PROJECT: Advanced Boiling Water Reactor (ABWR)

SUBJECT: SUMMARY OF MEETING WITH GE ON SEPTEMBER 9 AND 10, 1992

Proposed Disposition of NRC Comments on SLCS ITAAC

Figure 2.1.2f Safety-Action Valve Lift Characteristics

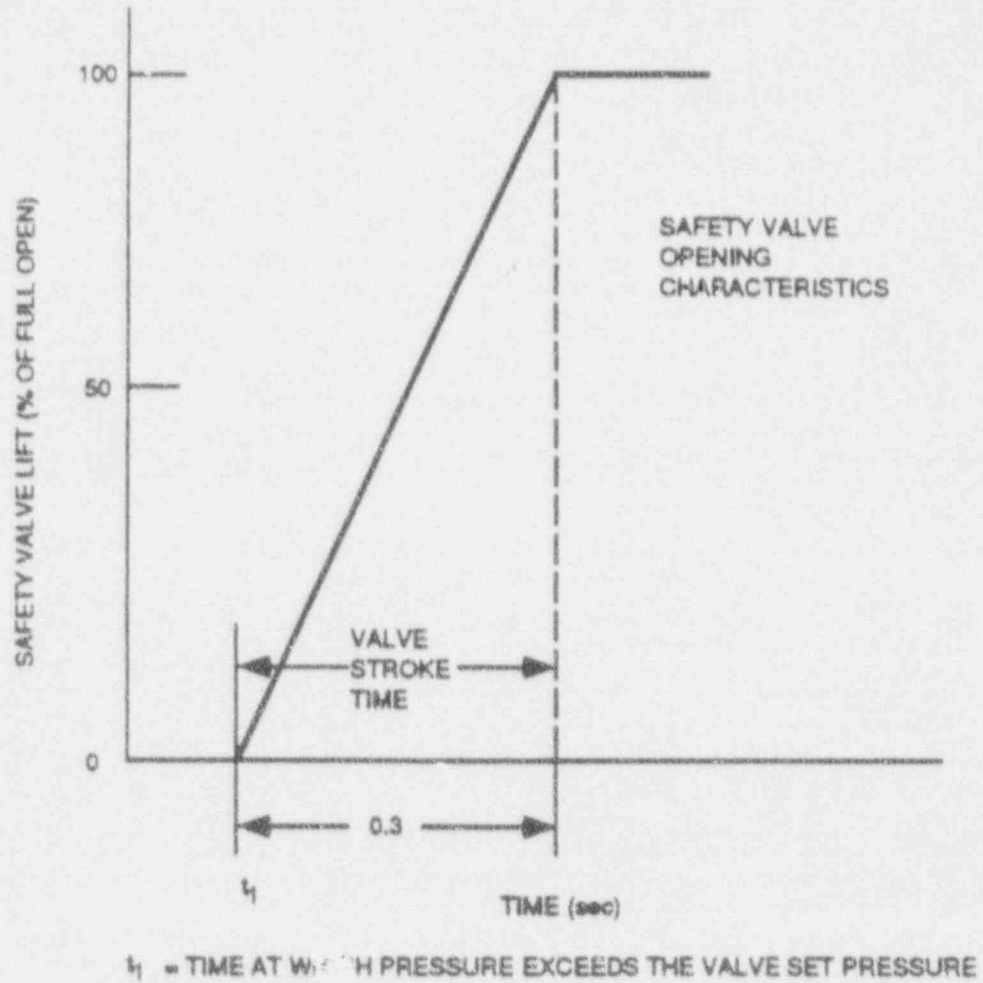
9. There shall be ^{ARE} 18 SRVs mounted on the MSLs as shown in Figure 2.1.2a. The required spring set pressure and capacities are given in Table 2.1.2a. The SRVs shall meet the opening performance shown in Figure 2.1.2f.	9. Inspections will be conducted to confirm that the SRVs have the required (nominal) spring set pressure and (minimum) capacity on the SRV nameplate. Visual inspections will be conducted to confirm that all 18 SRVs have been installed in their proper locations. TO REVIEW THE AS-BUILT SRVs. Review of the qualification test data for the particular SRV model selected to confirm that the opening performance complies with the requirements.	9. Inspection confirm that the SRVs have the required capacities and set pressures Identify SRV name plates. SHOW DATA FROM TABLE 2.1.2a. Inspections confirm that the proper capacity and set pressure SRV has been mounted in its correct location. ALL 18 SRVs WERE INSTALLED. Confirm that the selected SRV model satisfies the performance requirements of FIGURE 2.1.2f.
